Addendum # 1 Parks Maintenance Complex Wetland

Date of Addendum: 2/23/17

CENTER FOR WATERSHED PROTECTION
 Addendum
 Parks Maintenance Complex Wetland
 Wicomico County, Maryland

Cross Section A-A' (western end only)

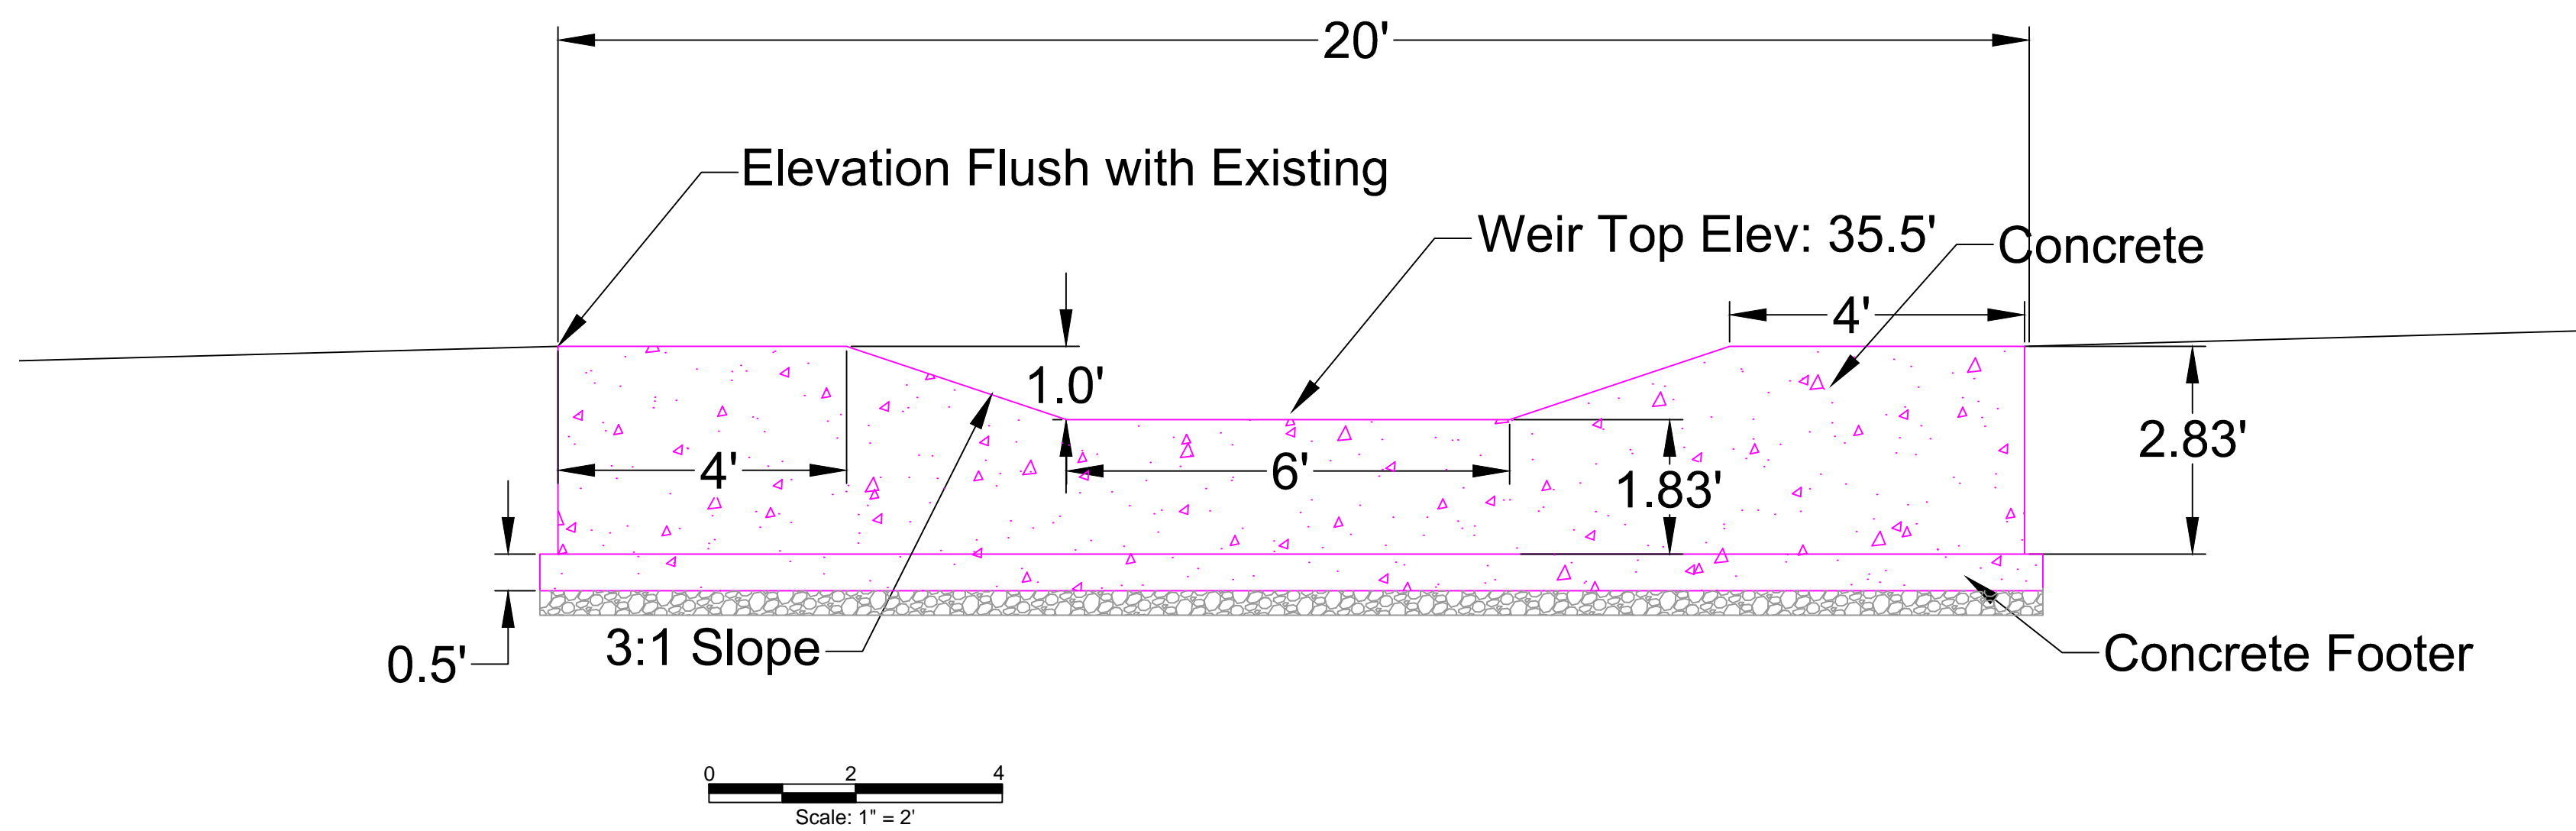
2.2	Q. We request more detailed information on the concrete installation. A. More detailed information provided in attached drawing.
2.3	Q. Cross Section A-A shows the concrete forebay with the concrete weir. The slope existing the first wetland cell is protected with riprap. Should the forebay outfall also be protected with riprap? A. Build per plans.

2.10	<p>Q. There are no footers or a turn down around the outside edge of the forebay. There should be at least a 12" turndown along the outside edges to combat erosion under the forebay.</p> <p>A. Footer and turndown added.</p>

Cross Section C-C' (middle of weir wall)

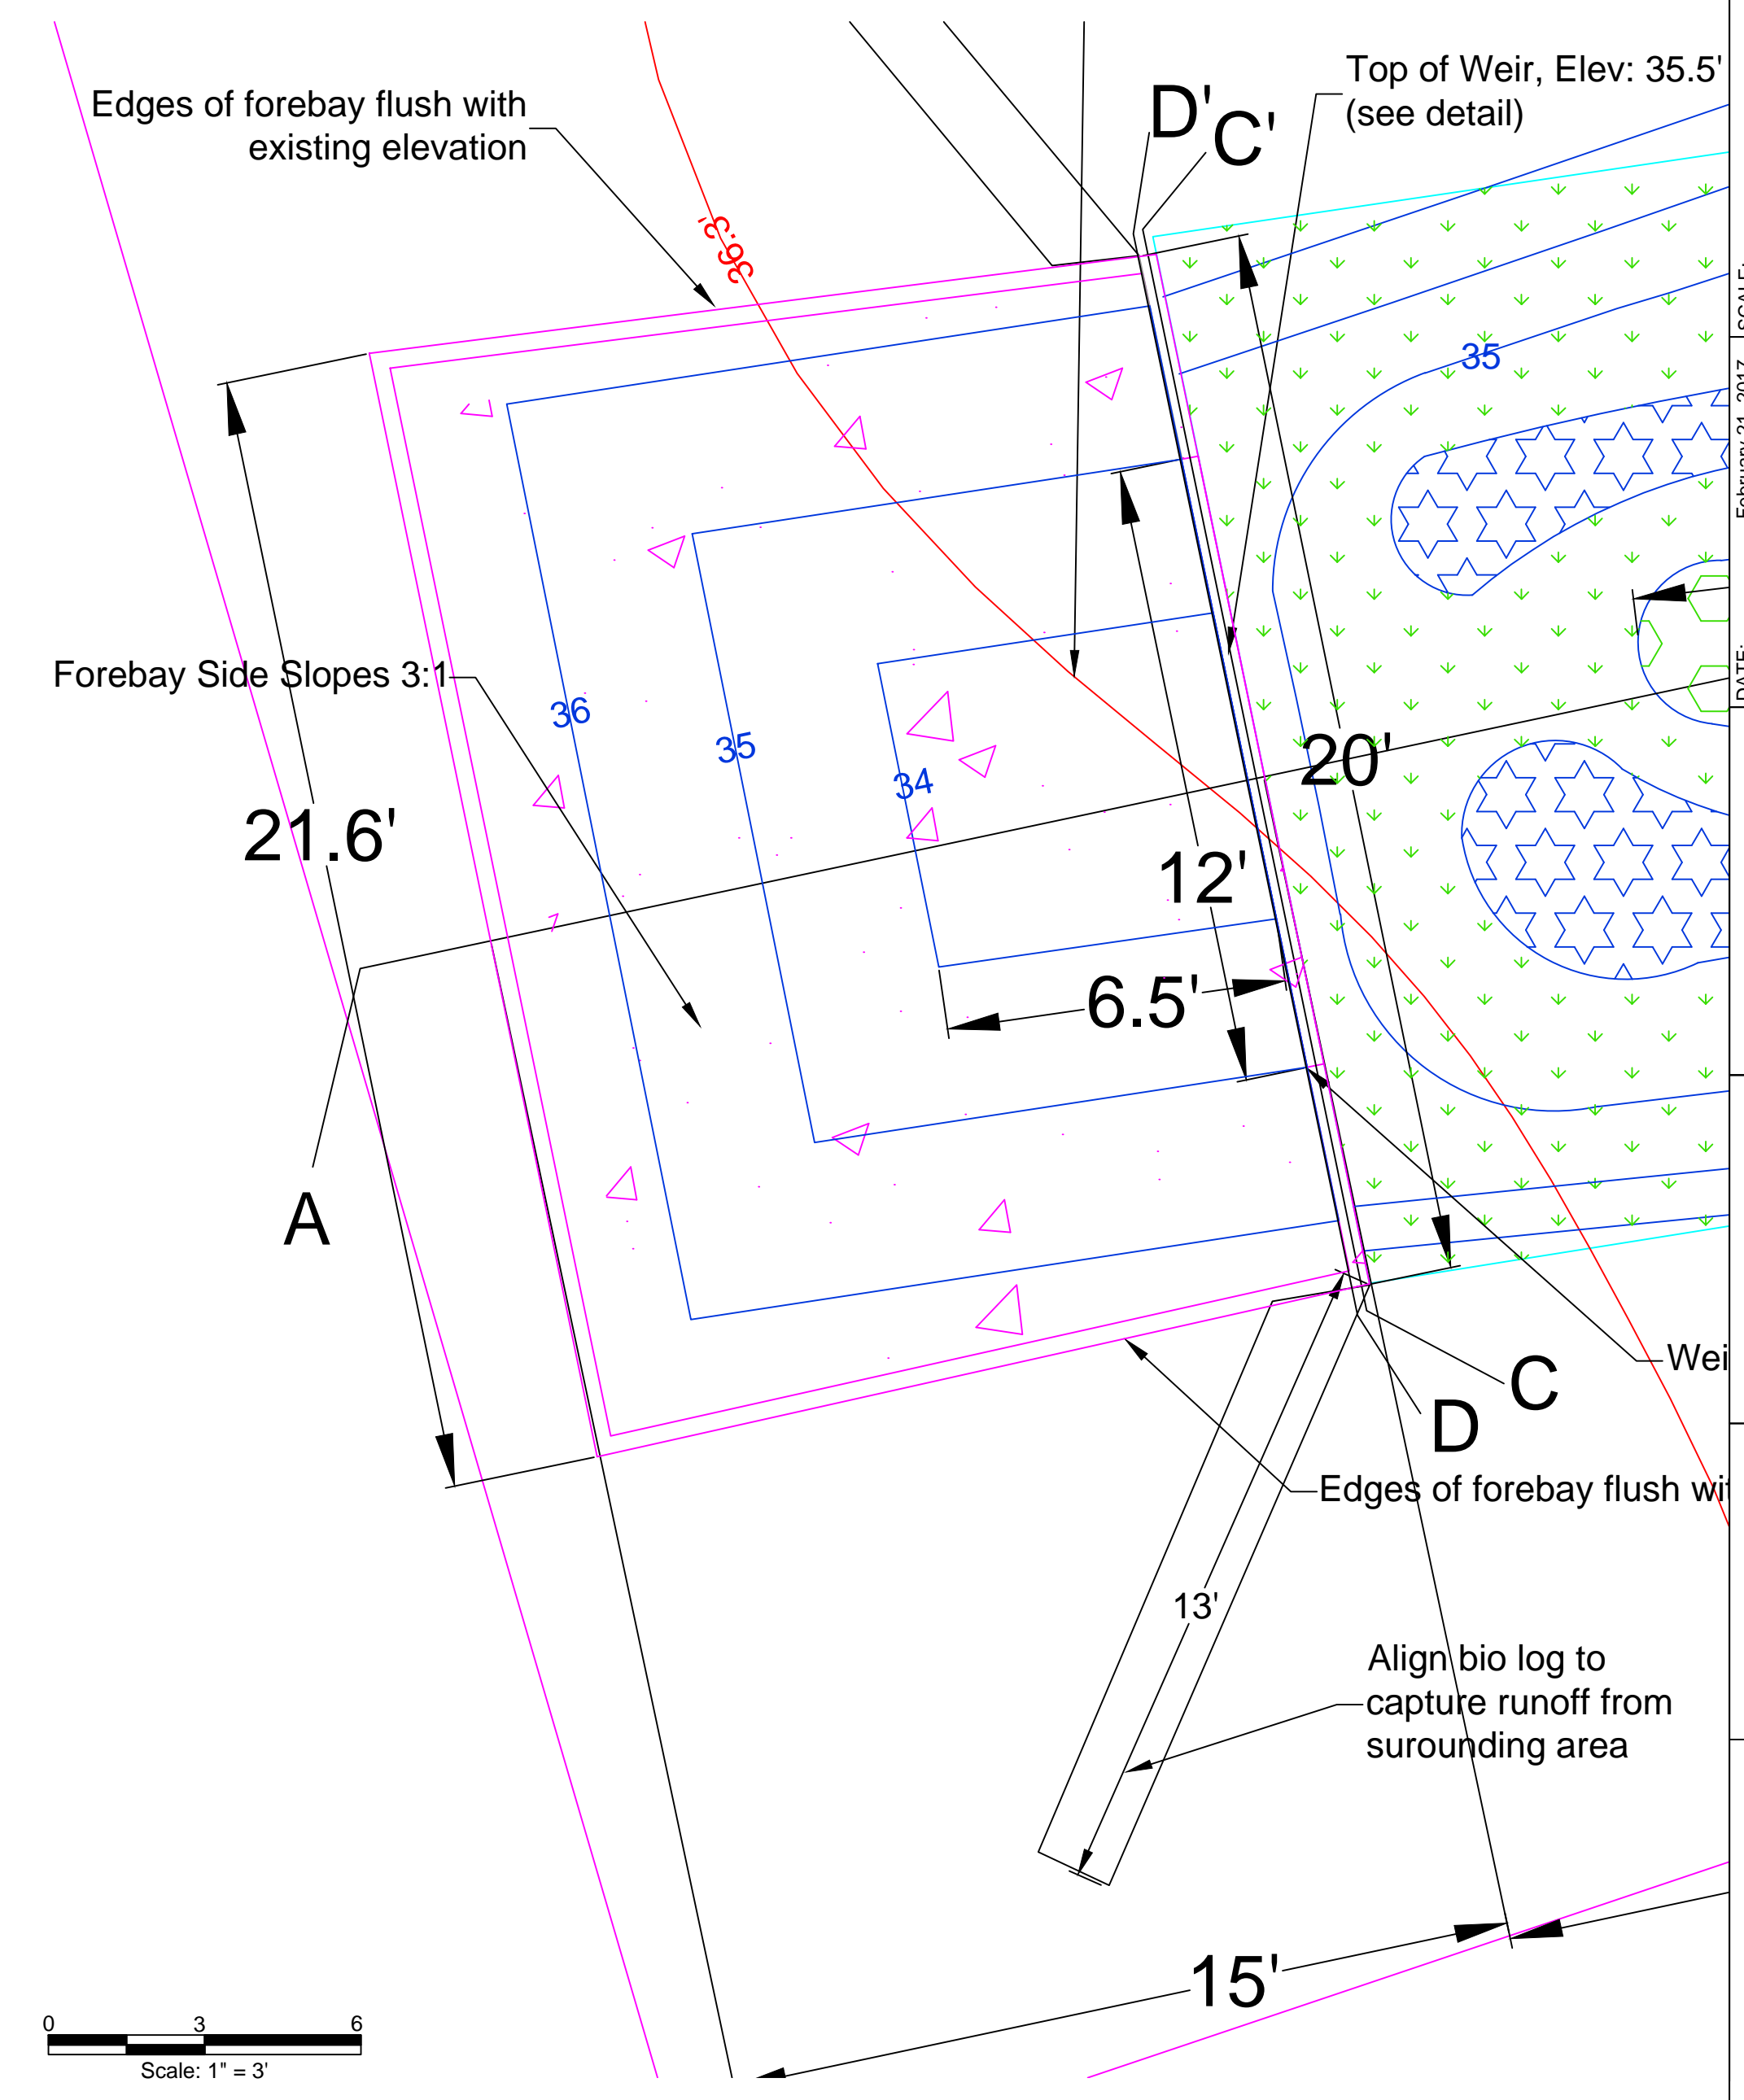
2.7	Q. Is any rebar in the concrete weir? None is shown in the detail. A. Revised specifications are forthcoming which will address this issue.
2.8	Q. Are all biologs to be 9' in diameter? A. Yes.

2.11	<p>Q. There is no footer under the Weir wall. What is going to hold it in place?</p> <p>A. Footer added to weir wall. This can be done as a monolithic pour.</p>

- Material Specifications:
- Gravel - 3/4 inch crushed rock, compacted
 - Concrete - concrete contains polypropylene fiber reinforcing with a fiber length of 0.75 inches minimum and mixed at a rate of 1.5 pounds per cubic yard of concrete.

Cross Section D-D' (where weir wall meets the forebay)

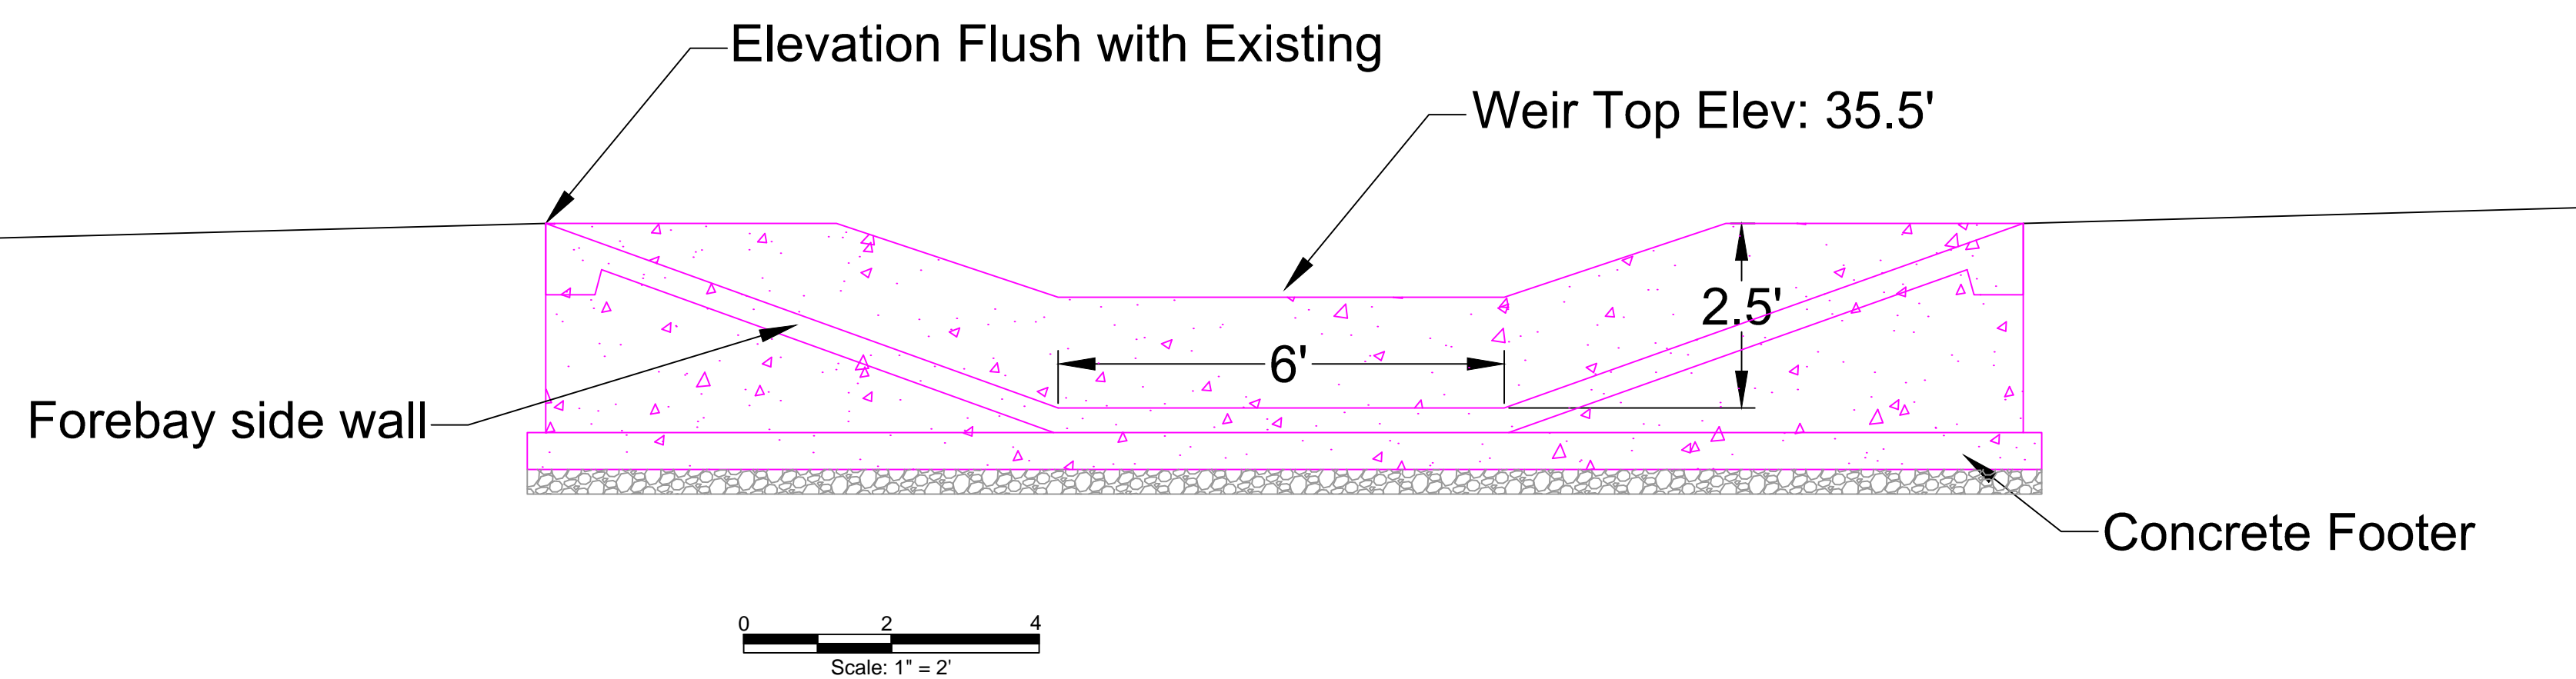
2.12	<p>Q. Does the forebay have to be a monolithic pour? If not, what material should be used to seal the seams?</p> <p>A. It does not need to be a monolithic pour. A suggested sealant is polyurethane joint sealant.</p>

2.13	<p>Q. What is to be used to connect the forebay to the weir wall? How thick is the weir wall?</p> <p>A. No connection needed between forebay and weir wall if soil is compacted. Weir wall is 6 inches thick.</p>

- Notes:
1. Compact soil below forebay.
 2. Use a polyurethane joint sealant between the weir wall and the forebay.
